E-470 Storage Subdivision Filing No. 1, Lot 1, Block 1
A parcel of land being a part of the South 1/2 of Section 25,
Township 4 South, Range 66 West of the Sixth Principal Meridian,
City of Aurora, County of Arapahoe, State of Colorado

PRELIMINARY DRAINAGE REPORT

Project:
470 Storage
Aurora, Colorado

February 6, 2018

Restrictor Plate

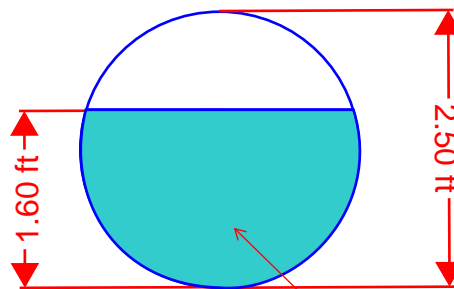
Revise based on comments made on previous sheets of this report. include a calc which clearly shows how the discharge rate is arrived at.

APPENDIX D – DRAINAGE MAP

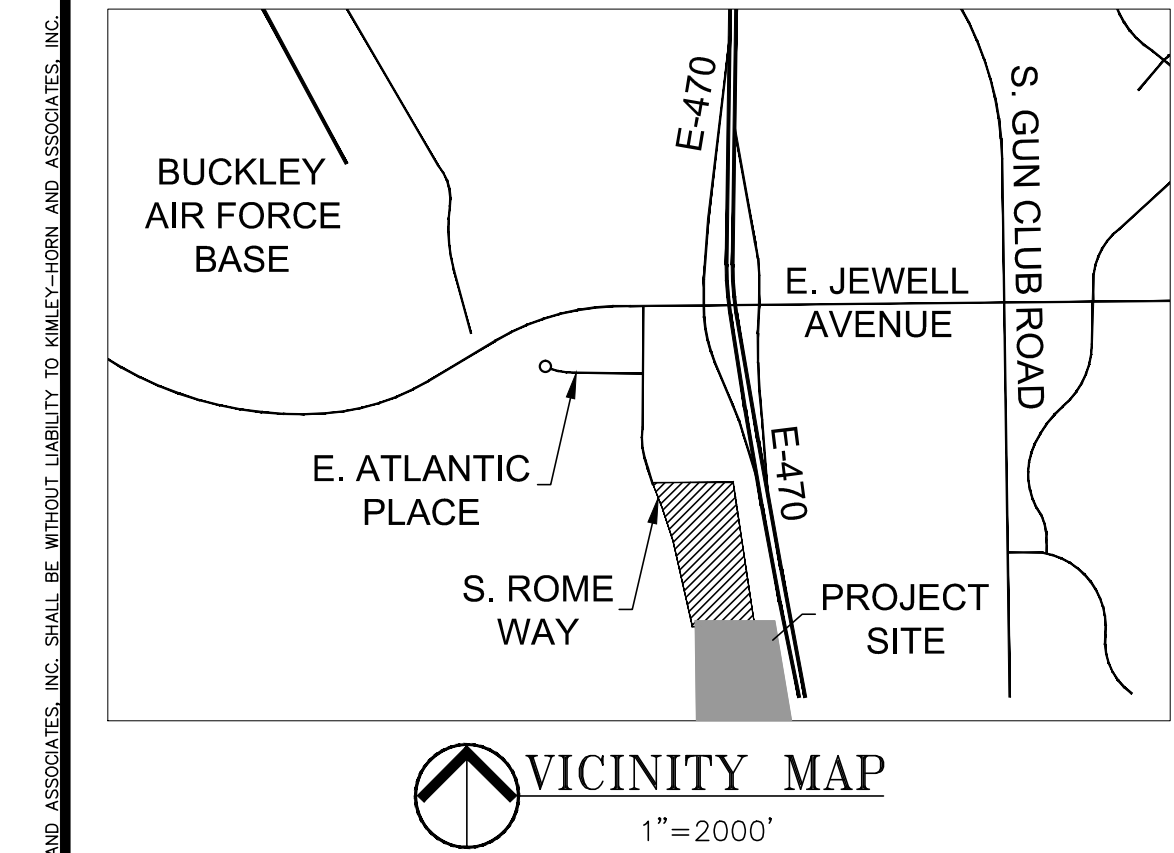
Add topo and flow direction arrows to clarify that this off-site area is not trib to your site - instead flows north in swale along Rome Way.

This area appears historically trib to your site basin F-1. Please show topo for and evaluate this area. City has 1ft contours available that can be used.

Topo downloaded from Aurora for report OS basins added

Topo downloaded from Aurora for report OS basins added
